**KING'S MARK
ENVIRONMENTAL REVIEW TEAM**

**REPORT FOR
BARKER'S CROSSING SUBDIVISION
NORFOLK, CONNECTICUT**

Environmental Review Team Report

Norfolk Inland Wetlands Commission

Figure 2

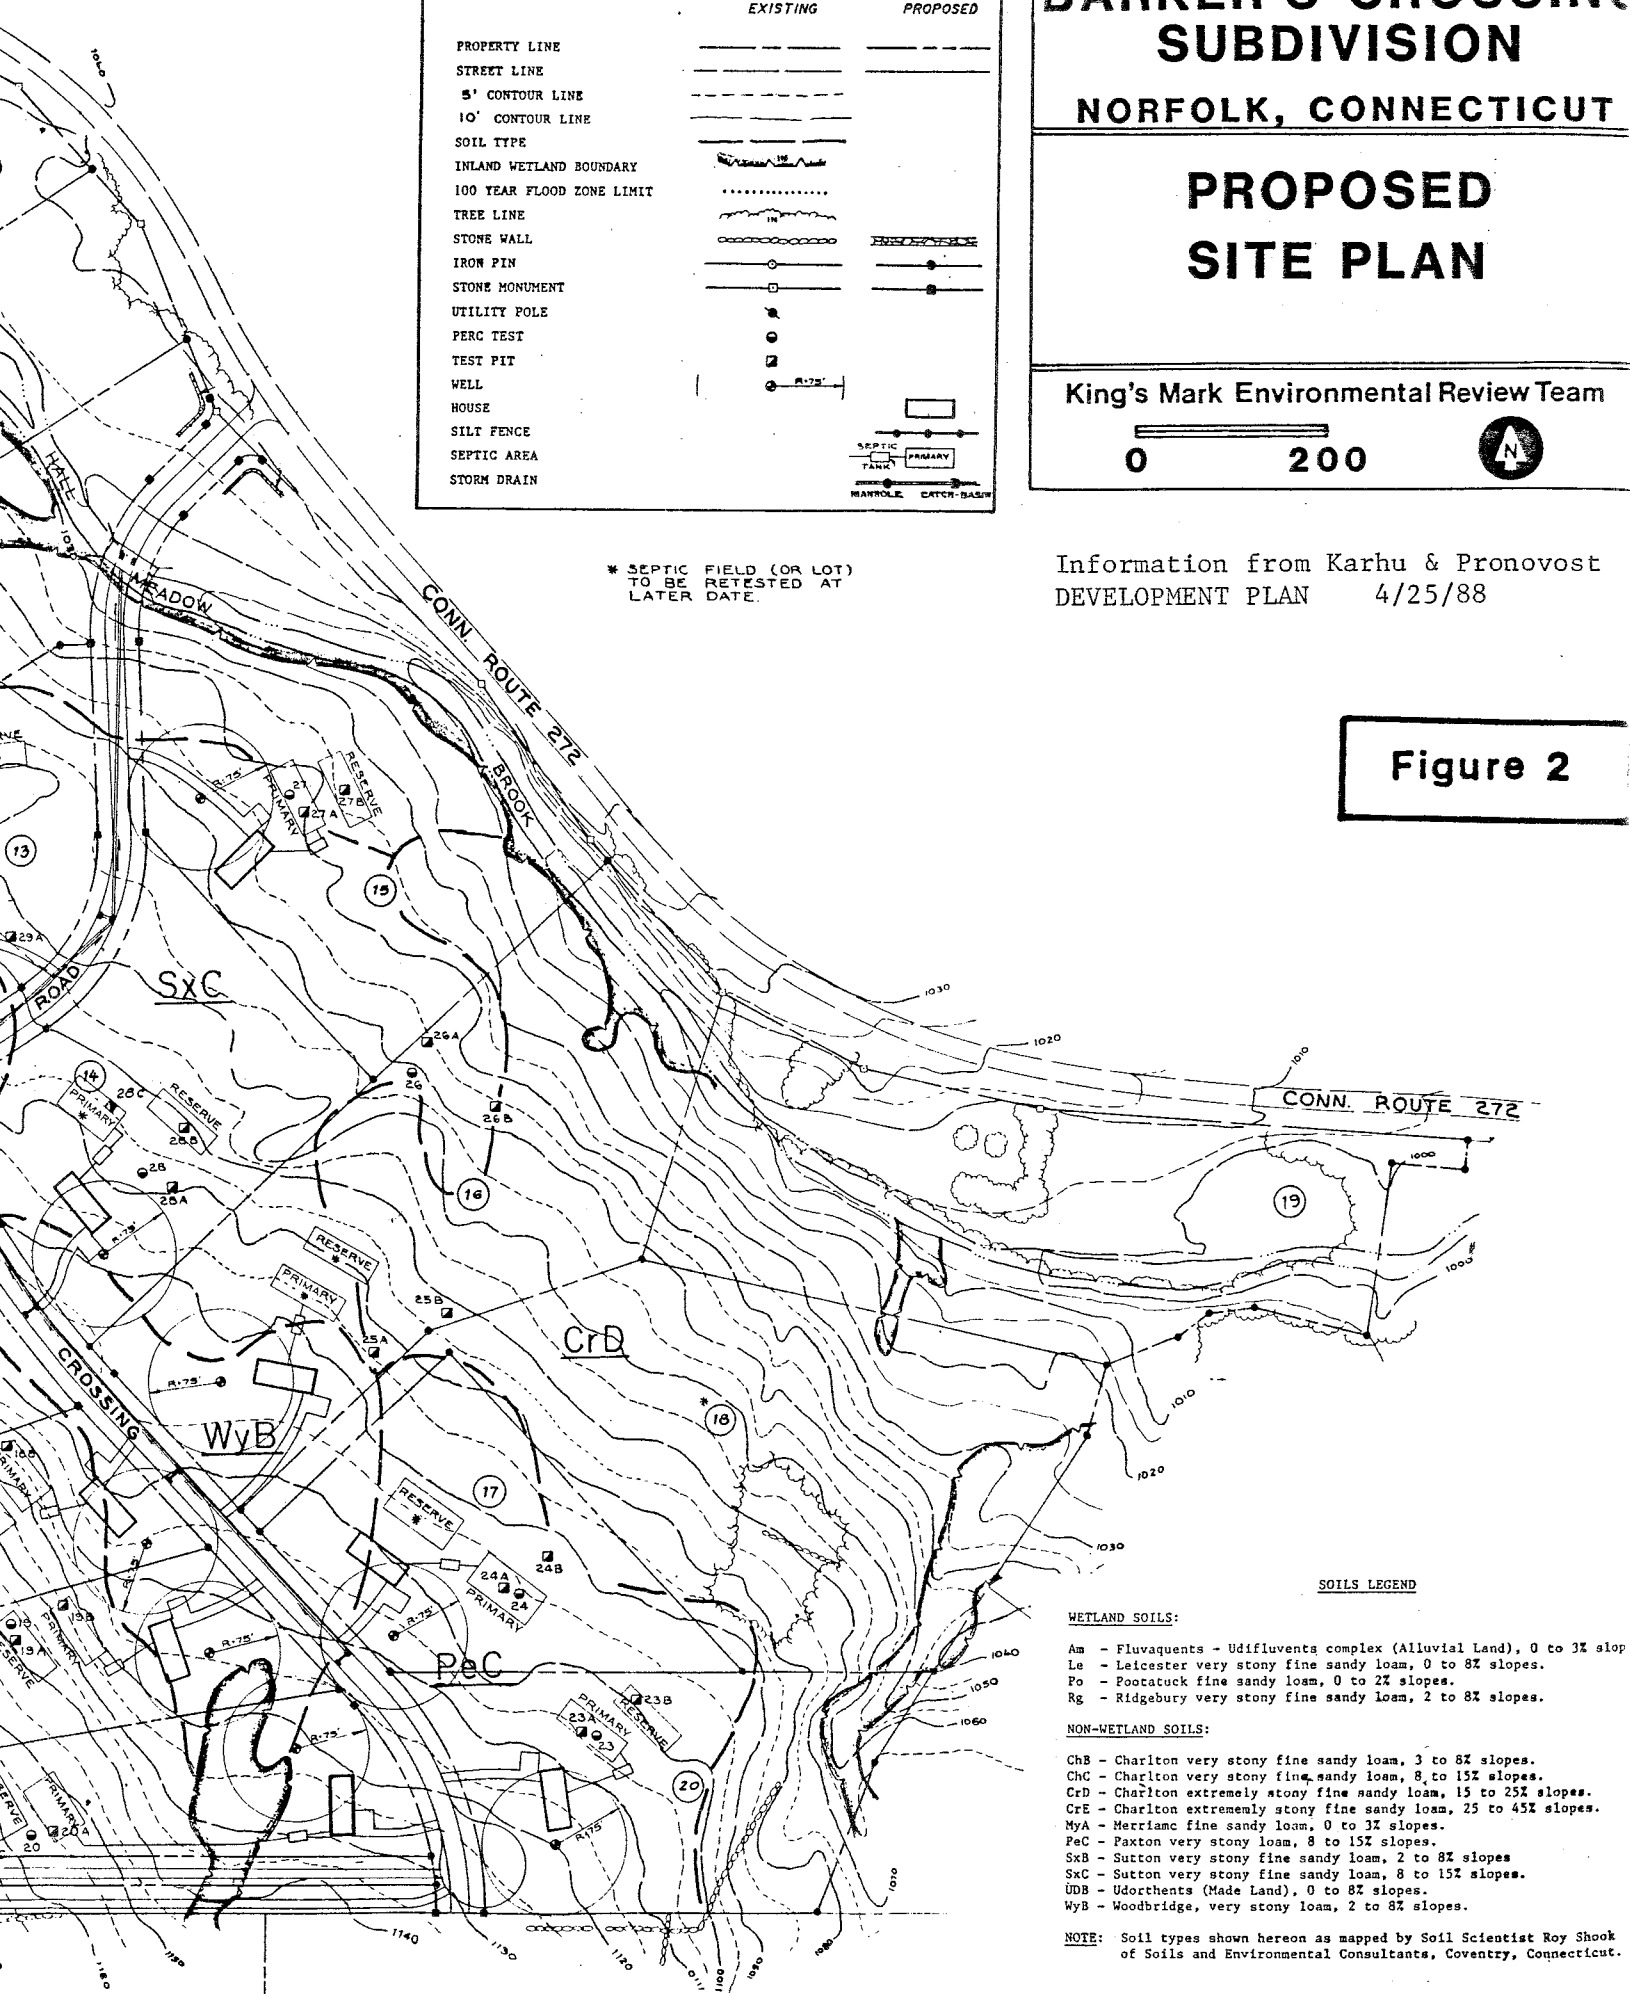
Based on the plot plan submitted to team members, Barker's Crossing and Brook Hill Road will need to cross Hall Meadow Brook and its accompanying wetland/floodplain in order to access the subdivision site. These wetland/stream crossings will be at the intersection of the road with Route 272. It also appears that driveways serving Lots 30 and 31 will need to cross regulated wetlands in order to access the lots. Wetland crossings for the latter are feasible and can be accomplished without much damage to wetlands provided they are properly designed (e.g., culverts are properly sized and installed and permeable road base fill material is used). The driveways should be constructed at least 1.5 feet and preferably 2 feet above the surface elevation of the wetlands. This will allow for better drainage of the roads and decrease the frost heaving potential of the road. It is recommended that any road construction through wetland areas be done during the dry time of year with adequate provisions for effective erosion and sediment control. It is strongly suggested that the applicant be required to submit detailed plans for all wetland crossings. The plans would indicate specific site development details, erosion and sediment control measures, fill lines, amount of fill to be placed, the impacts of filling, watercourse channel location and flow direction, disturbed areas, etc. Approved wetland activity needs to be closely monitored by town officials. Consideration should be given to a shared driveway for Lots 30 and 31 to minimize wetland disturbance in the area.

given to eliminating the Brook Hill Road crossing of Hall Meadow Brook. Perhaps a driveway between Lots 13 and 14 could be constructed to serve Lot 15, thus eliminating the crossing of Hall Meadow Brook and its wetlands

- 7) The driveway grading plan for Lots 30 and 31 should be shown to determine if driveway construction is feasible with the current lot layout. The Sanitary Engineer's report (Saglimeni, 4/88) states ledge was hit on test pits for both these lots. This indicates blasting may be needed for driveway cuts.

- 11) No calculations were submitted for review which show how the net increase of 15 cubic feet per second (cfs) was obtained for post development runoff.

- 2) Due to the steep grades and length of the proposed right of ways servicing Lots 30 and 31, consideration should be given to combining these lots with other proposed lots and/or providing access off Brook Hill Road to these two lots. This second alternative would require additional re-design of the project to accommodate Norfolk's subdivision requirement of no more than 10 lots on a dead end road.

Figure 6

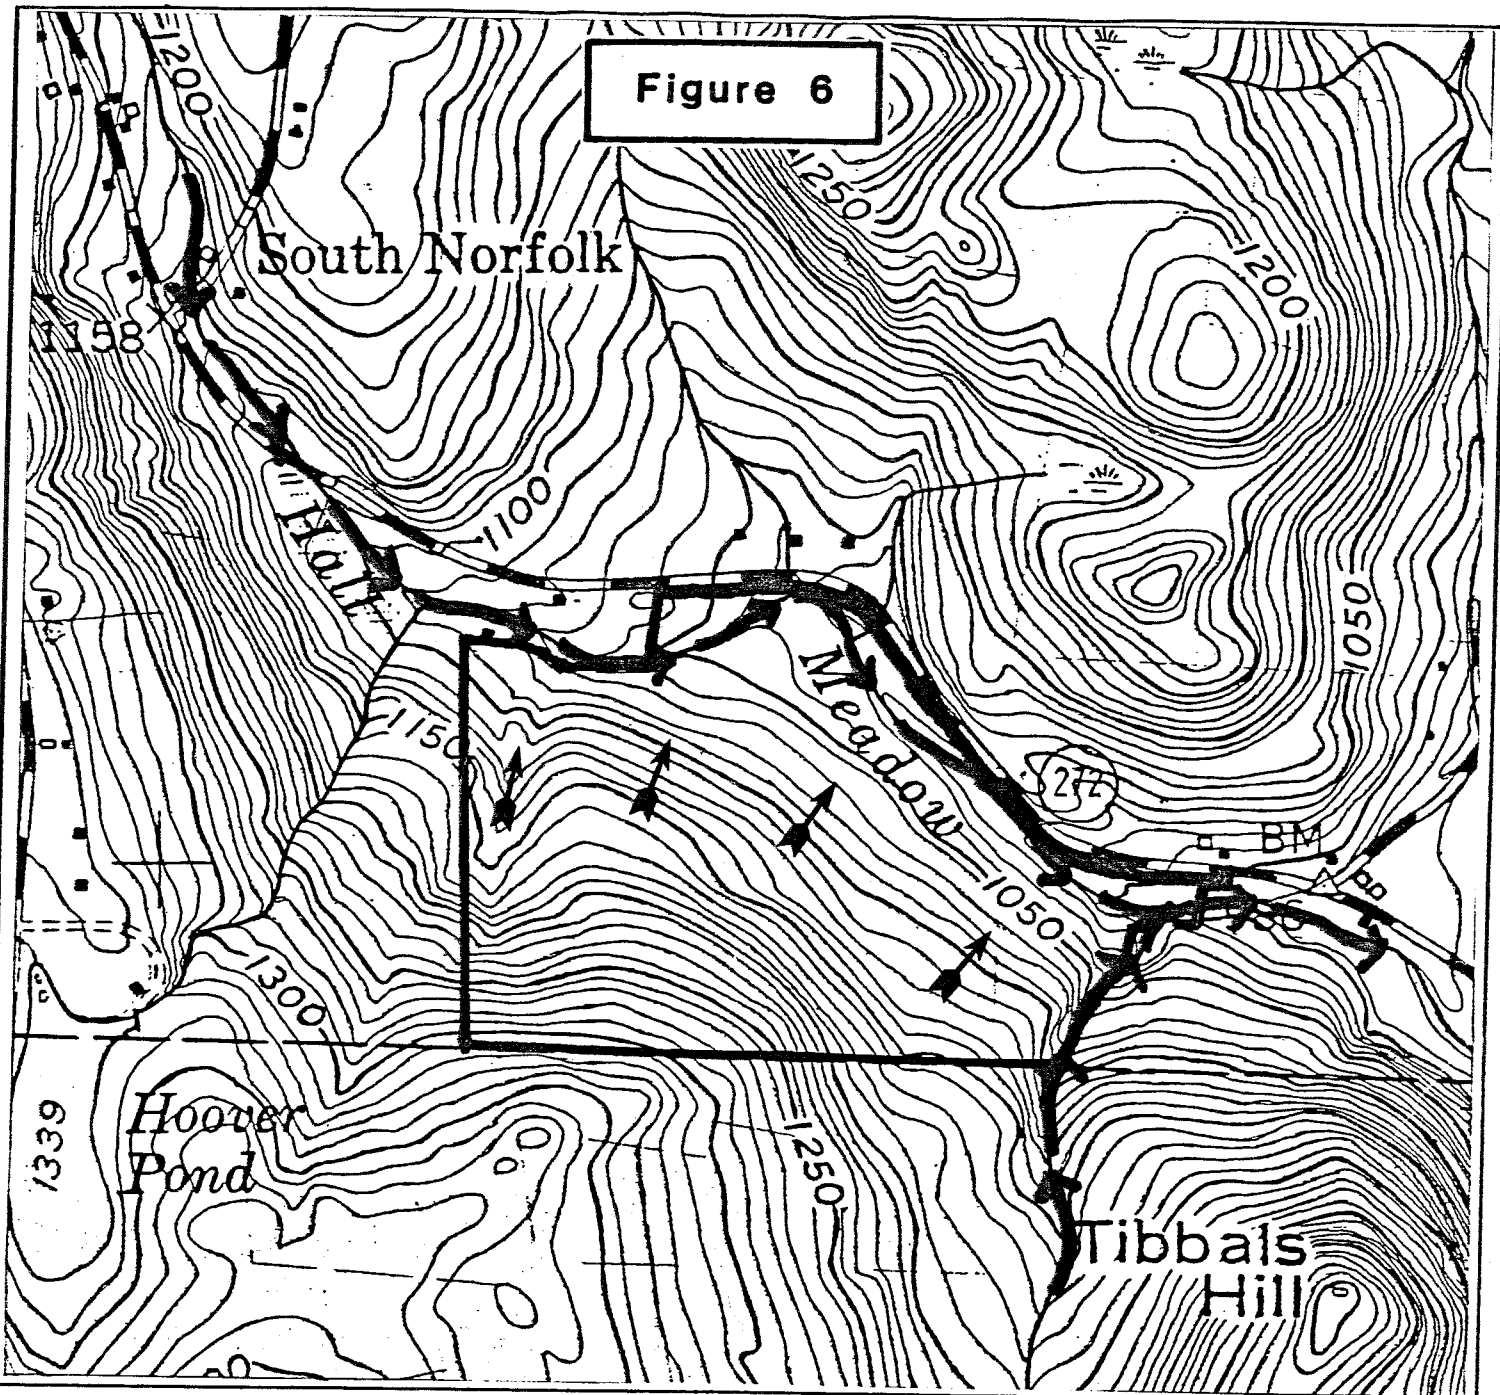
The applicant's engineer has demonstrated that development of the site for residential use will lead to increases in the amount of runoff shed from the parcel. The amount of increases will depend upon the extent of development, the impervious surfaces created and the amount of vegetation removed or preserved. Present plans indicate that road drainage will be artificially collected and outletted to Hall Meadow Brook at the proposed road crossing. It is not known if roof gutters will be discharged to road drainage.

The developer of the parcel should analyze the lots individually and collectively. The need for detention should be based on density, amount of wetlands and associated storage and calculated runoff increases. If detention is warranted, it should be located where its effects would be maximized and its impact on the wetland minimized. Ideally, if detention basins are required to handle post-development flows, they should be located on upland soils. However, because of the steep slopes and shallow to bedrock soils, it may not be possible to do this. As a result, there may be a need to use wetland pockets within the site as detention areas. Finally, all downstream culverts should be carefully examined.
